APPLICATION NO.	FILING DATE	FIRST NAMED INVENTOR	ATTORNEY DOCKET NO.	CONFIRMATION NO.
10/667,115	09/19/2003	Russell Norman Mirov	SUN03-0112	8531
57913	7590	02/28/2007	EXAMINER	
SUN MICROSYSTEMS, INC. c/o PARK VAUGHAN & FLEMING, LLP P.O. BOX 7865 FREMONT, CA 94537			DINH, TUAN T	
			ART UNIT	PAPER NUMBER
			2841	
SHORTENED STATUTORY PERIOD OF RESPONSE		MAIL DATE	DELIVERY MODE	
3 MONTHS		02/28/2007	PAPER

Office Action Summary	Application No.	Applicant(s)	
	10/667,115	MIROV, RUSSELL NORMAN	
	Examiner	Art Unit	
	Tuan T. Dinh	2841

DETAILED ACTION

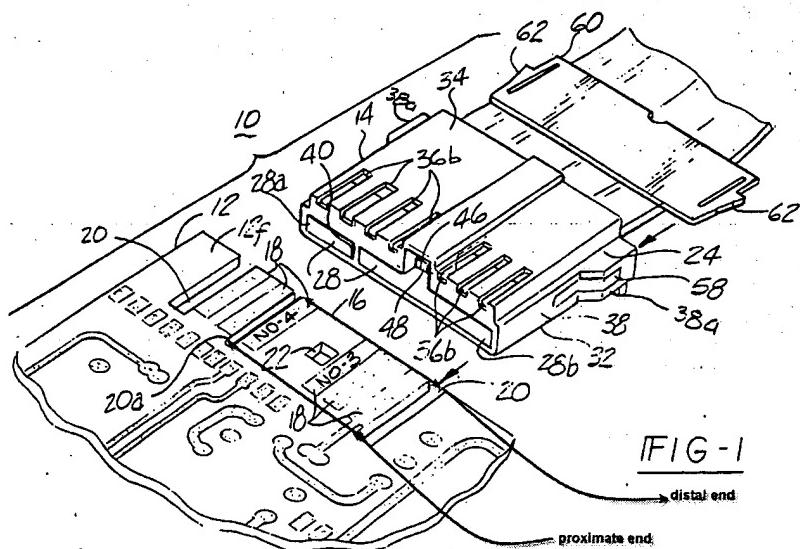
8. Claims 1-3, 5-7, 34-36, and 39-42 are rejected under 35 U.S.C. 102(b) as being anticipated by Matson et al. (U.S. Patent 4,685,112).

As to claims 1-3, Matson discloses a circuit board (12, column 2, line 7) as shown in figures 1-2 comprising: a mechanism (16, column 2, line 9) comprising:

signal means for (wire traces 18, and circuitries formed in/on the circuit board 12) conducting a signal between the mechanism (16) and the circuit board (12); and separation means (gaps 20, column 2, line 15) for facilitating detachment of the mechanism (16) from the circuit board (12); identification means for (labels No.1-No.6, figure 1 shows the label No.3 and No.4) identifying the mechanism (16);

As to claims 5-7, Matson discloses in figure 1 the identification means being a circuit (conductor run (18), visible identification code (labels No. 3, No. 4), and being protected (by a molded connector 14) from being easily manipulated.

16) having: proximate and distal ends (see figure above); and two opposing sides separated from the assembly by gaps (slots 20); an identification (labels N0.1-No.6 formed on conductor runs 18 to identify the function of leads/pins of the conductor runs) situated on the tab (16); and a signal conductor (traces or wirings on the board) extending from the circuit board to the tab and configured to convey a signal when the assembly is powered.

As to claim 42, Matson discloses the signal conductor (traces) does not extend to the distal end of the tab (16).

Examiner disagrees. Figure 1 of Matson shows conductor runs (18) having identification means (labels No. 3, No. 4) of a plug (16) for providing positive mechanical locking of a connector (14) and the plug (16), further, the conductor runs formed on a PCB (12).
